Service Update #25-0514

High Voltage Errors When Humid/Wet on L-N Model “HAB”

Blue Bird 280 AMP – Part #10044860

Source: Prestolite Leece-Neville Heavy Duty Systems
Bulletin No: TSB-1224 **Date:** March 01, 2023
Models: HAB (Idle Pro Extreme) 12V alternators
Subject: Intermittent high voltage readings when remote sense is not used.

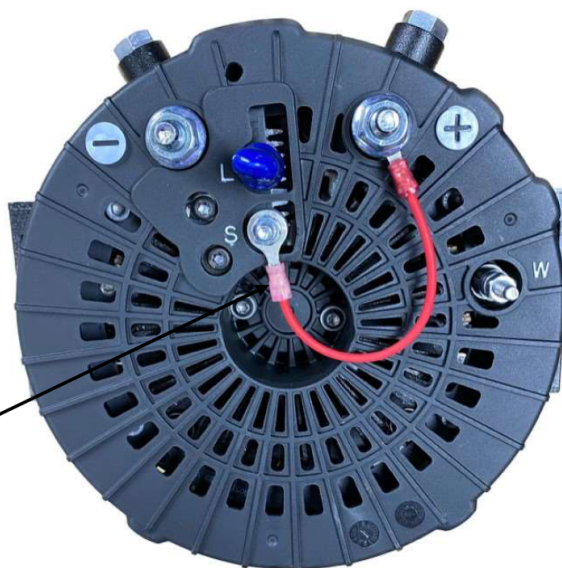
If you are experiencing the alternator operating at a voltage higher than 14.5V while not using the remote sense terminal (S). Very high humidity or wet conditions could cause this to happen.

By connecting a jumper wire between the alternator's B+ and Sense (S) terminals will correct this condition.

Jumper part number: A049104702S

+ Terminal Torque: 53 +/- 11 in - lbs.
6 +/- 1.2 Nm

S Terminal Torque: 18-22 in - lbs.
2.0-2.5 Nm

A049104702S jumper wire

FIGURE #2

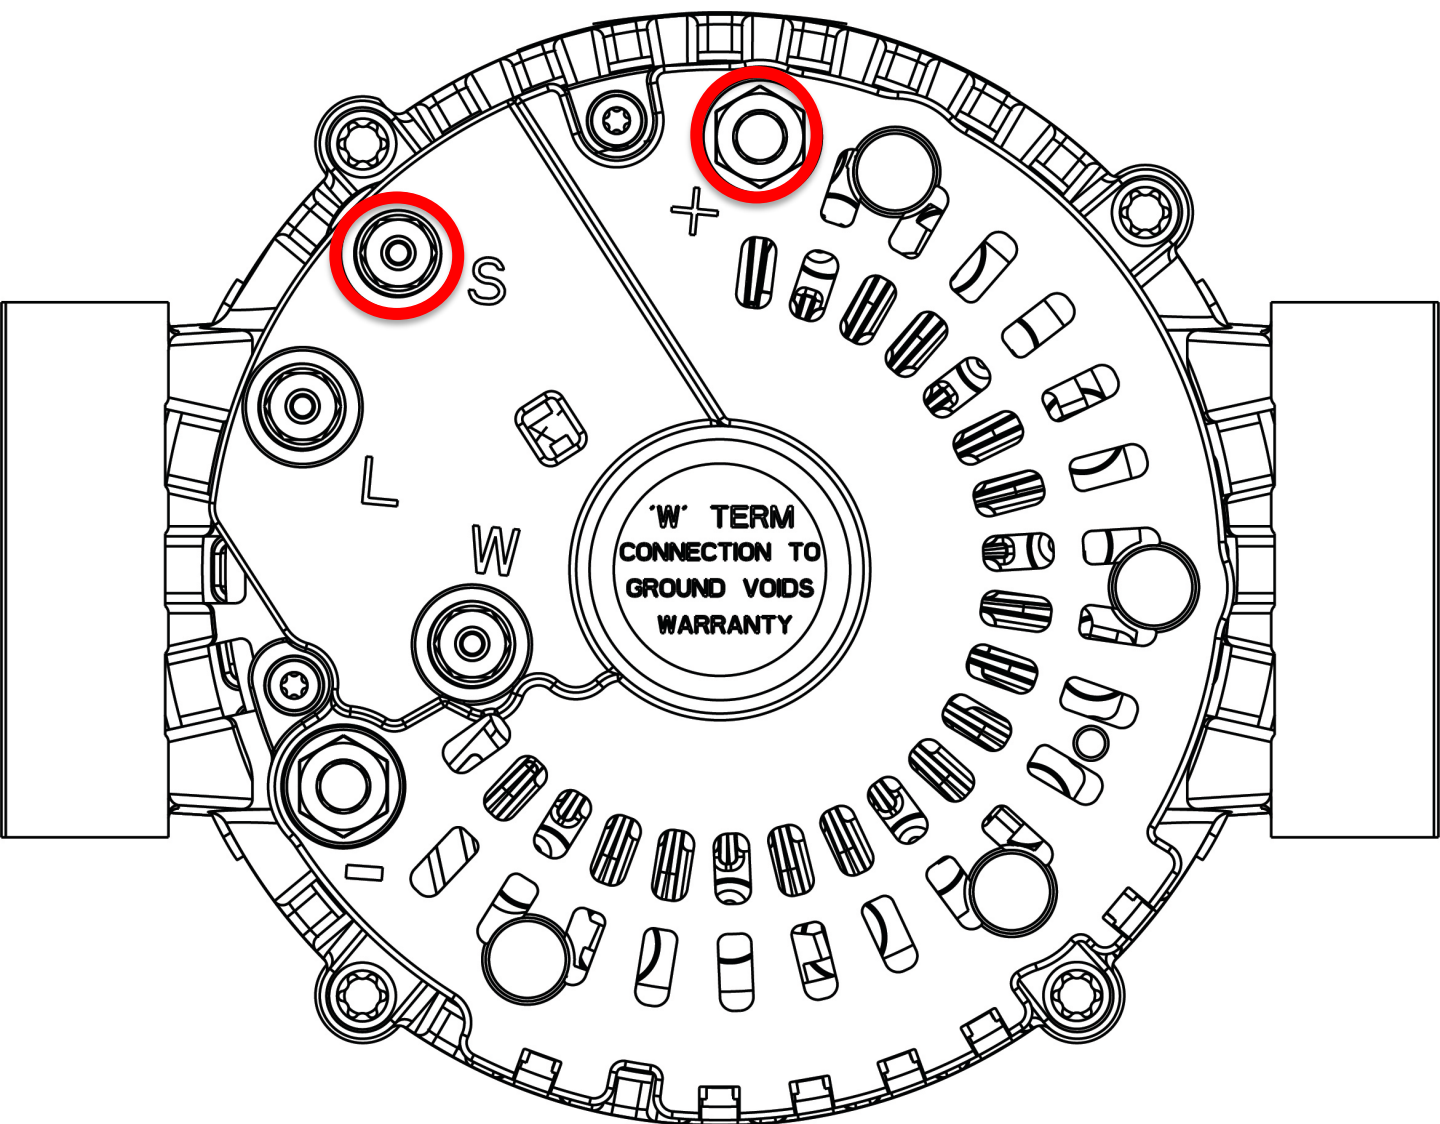
Positioning of the B+ and S terminals are not necessarily in the same position from the various AMP ratings of the model AVI160. The 240 AMP unit has a slightly different position as shown in FIGURE #2 above, both terminals are circled in **RED**.

FIGURE #1

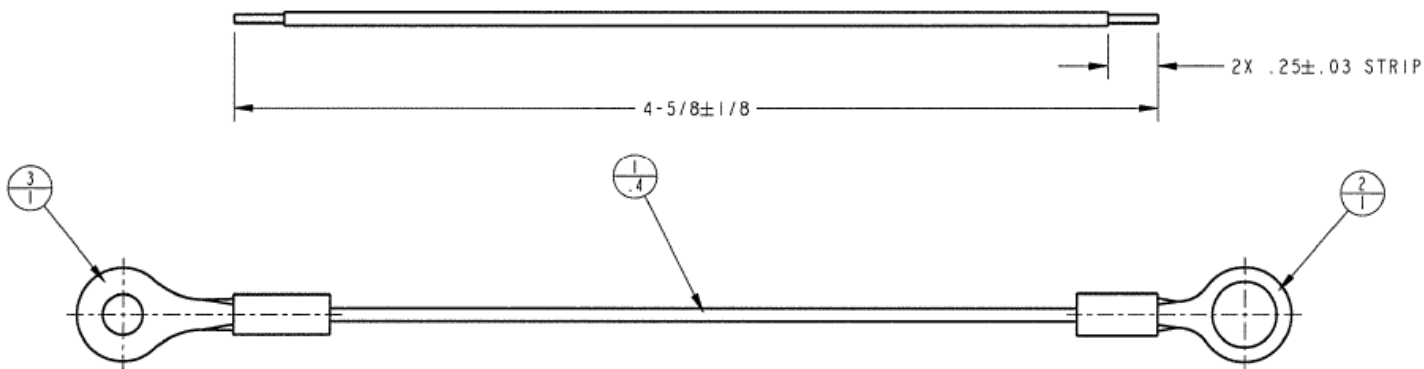
We have found that the jumper part number is not readily available, but we were able to get the specs on the jumper and found that most shops carry the common supplies to make the jumper. (FIGURE #1)

The jumper can be made using the supplies listed below by taking the wire, stripping $\frac{1}{4}$ " of insulation off of each end and then crimping the terminals on each end.

REQUIRED SUPPLIES

- 1 4-5/8" 18ga. RED WIRE
- 1 5/16" RED RING TERMINAL
- 1 #12 RED RING TERMINAL
